Access Compliance Report

Public Rights-of-Way

(Curb Ramps)

Intersection ID: 18790	Main Street: KIRKPATRICK_RD	Cross Street: RAMA_RD	Location: W
ADA ID: 0793F652760F	Ramp Type: PerpDiag	Initial Pass/Fail: Fail	Overall Compliance: No
			Severity Score: 13.75

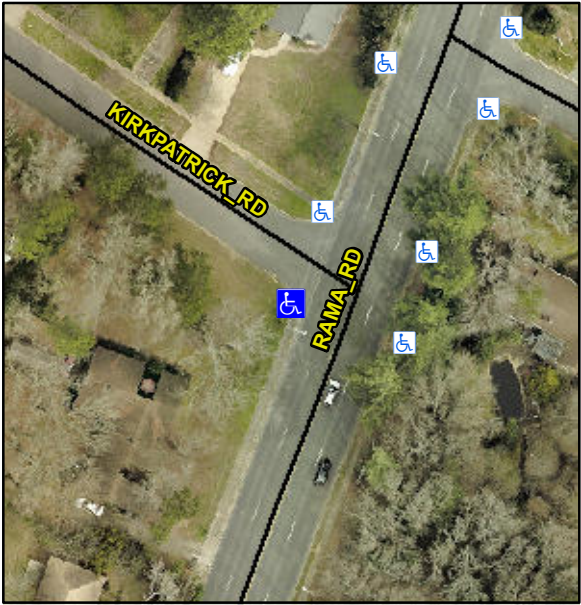
Codes/Mitigation Info/Possible Solution			Field Measurements/Component Compliance		
	Possible Solutions:		Compliance	Description	Data
	Remove & Replace Curb Ramp With Two New Directional Ramps or Equivalent.		No	Ramp Length (in)	58.0
			Yes	Ramp Width (in)	48.0
			N/A	Flare Type LT	N/A
			N/A	Flare Slope LT (%)	N/A
			N/A	Flare Traversable LT?	N/A
			N/A	Landing Length (in)	N/A
			N/A	Landing Width (in)	N/A
			N/A	Landing Slope (%)	N/A
			N/A	Landing X Slope (%)	N/A
<p>Surveyor Notes:</p> <p>N/A</p> <p>PROW/ADA:</p> <p>Not Found, R304.2.2, R304.5.3</p>			N/A	Flare Type RT	N/A
			N/A	Flare Slope RT (%)	N/A
			N/A	Flare Traversable RT?	N/A
			N/A	DWS Provided?	N/A
			N/A	DWS Contrast?	N/A
			N/A	DWS Length (in)	N/A
			N/A	DWS Full Width?	N/A
			N/A	DWS Offset (in)	N/A
			N/A	Gutter Ponding?	N/A
			N/A	Gutter Lip Ht (in)	N/A
			No	Painted X Walk1?	No
				X Walk 1 Direction	To SE
			N/A	X Walk 1 Width (in)	N/A
				X Walk 1 Slope (%)	1.1

X Walk 1 X Slope (%)	1.3
			N/A	Ramp inside XWalk1?	N/A
			2.7	Road Slope (%)	N/A
			1.0	Road X Slope (%)	N/A
			N/A	Any Obstructions?	N/A
				Obstruction Type	
			N/A	Clear Space?	N/A
			N/A	Clear Space to XWalk (in)	N/A
			N/A	Storm Grate/Utility Hazard?	N/A
				Storm Grate/Utility Type	
			N/A		N/A
			Yes	Surface Condition? (G/P)	Good
Total Cost:		\$ 3200.00
